**On-Base Groundwater Remediation
On-Base Groundwater Areas of Concern
Former Griffiss Air Force Base
Rome, New York**

**Final
PERFORMANCE MONITORING
WORK PLAN**

SUBJECT: Final Performance Monitoring Work Plan, On-Base Groundwater Areas of Concern.

**RESPONSE TO EPA COMMENTS ON
TECHNICAL REVIEW OF THE DRAFT
PERFORMANCE MONITORING WORK PLAN
ON-BASE GROUNDWATER AREAS OF CONCERN
FORMER GRIFFISS AIR FORCE BASE
ROME, NEW YORK
AUGUST 2008**

Figure 2-1: LF6 TCE Sampling Locations

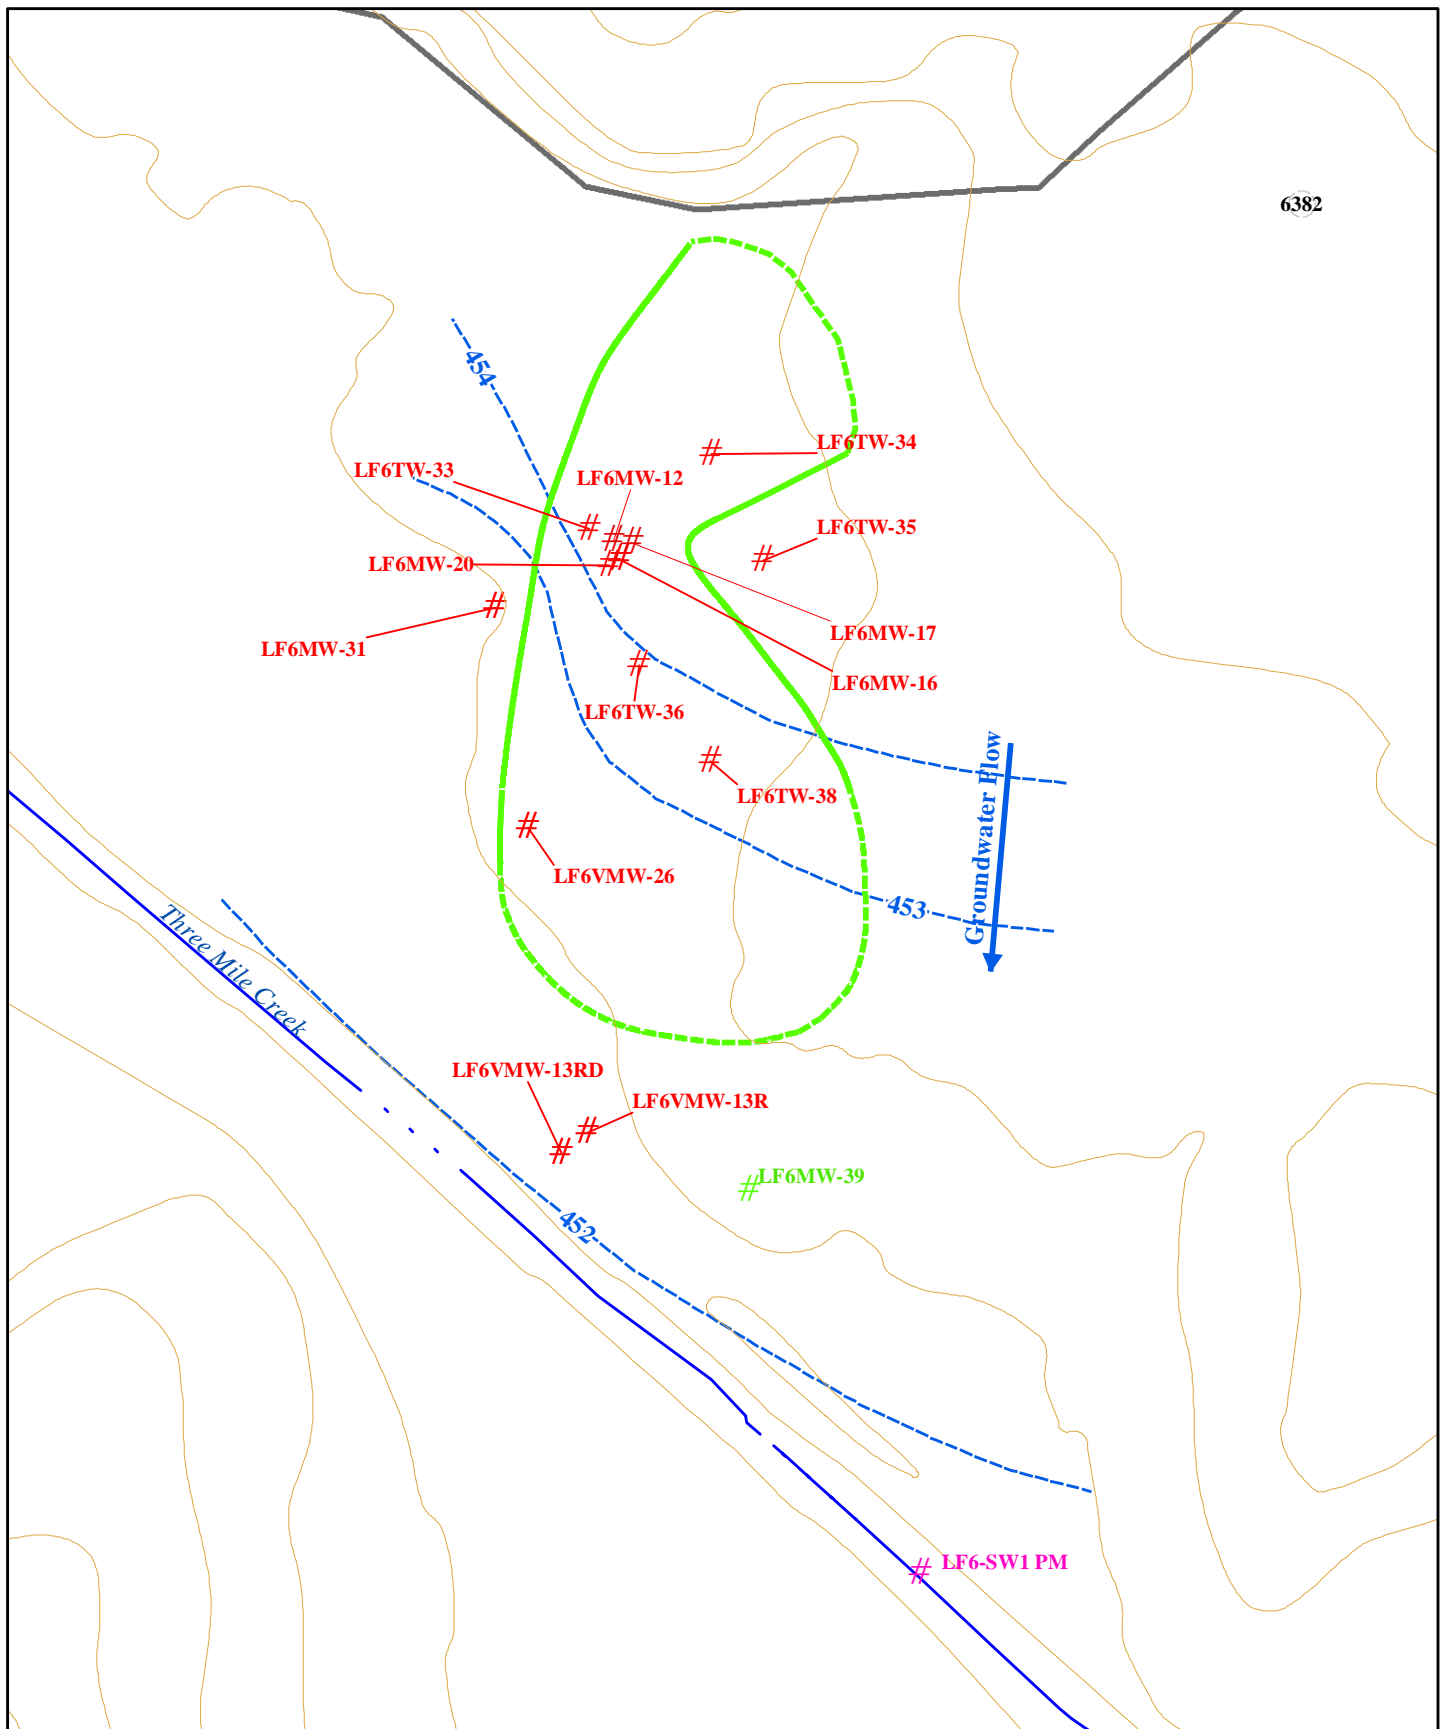
Specific Comments		
1	<p>Section 2.1, Site Background, Page 2-1: Three times, Section 2.1 references well LF6MW-12 citing figures from past documents related to this site. For example, the first paragraph refers to two contaminants exceeding the New York State Department of Environmental Conservation (NYSDEC) Class GA Groundwater Standards,</p>	<p>The well will be added to the figure.</p>

<p>trichloroethene (TCE) and dichloroethene (DCE), "located within a 1,600-square-foot area around well LF6MW-12 shown on Figure 2-1 (EEEEPC, February 2008)." Well LF6MW-12 appears to be an important part of the site background. For increased clarity and transparency in the presentation of information related to site conditions, please add well LF6MW-12 to Figure 2-1 of the PM Work Plan.</p>	
2	<p>Section 2.1, Site Background, Page 2-1: The third and fourth paragraphs of Section 2.1 indicate that the results of sampling conducted in November 2006 and February through April 2007 are presented in the Final Monitoring Report, Baseline and PDI2 Sampling at On-Base Groundwater AOCs, Griffiss Air Force Base dated August 2007 (Final Monitoring Report). However, the impact of the results on the performance monitoring sampling strategy for the TCE plume at Landfill 6 is not presented or discussed. It is suggested that the results of this sampling event be presented and summarized in the PM Work Plan.</p> <p>Further, the revised text should demonstrate how the results were used to develop the performance monitoring strategy for the implemented remedy, enhanced bioremediation. Alternatively, indicate that presentation and discussion of the results is unwarranted as they did not influence the performance monitoring strategy.</p>	<p>The Baseline, PDI, and PDI2 results from 2006/2007 were evaluated to confirm the sampling networks during the preparation of the Remedial Design Work Plan (RD WP) and 90% Design Drawings dated February 2008.</p> <p>The Performance Monitoring Work Plan (PM WP) summarizes the sampling networks detailed in the RD WP. It is prepared as a stand alone document and is intended as a reference document for field personnel to provide guidance for site identification, site layout, sampling locations, analyses to be collected, sampling procedures, and documentation and shipping procedures. The PM WP also establishes future reporting.</p> <p>The baseline monitoring network proved sufficient to track the nature and extent of the plume and no changes were recommended.</p>
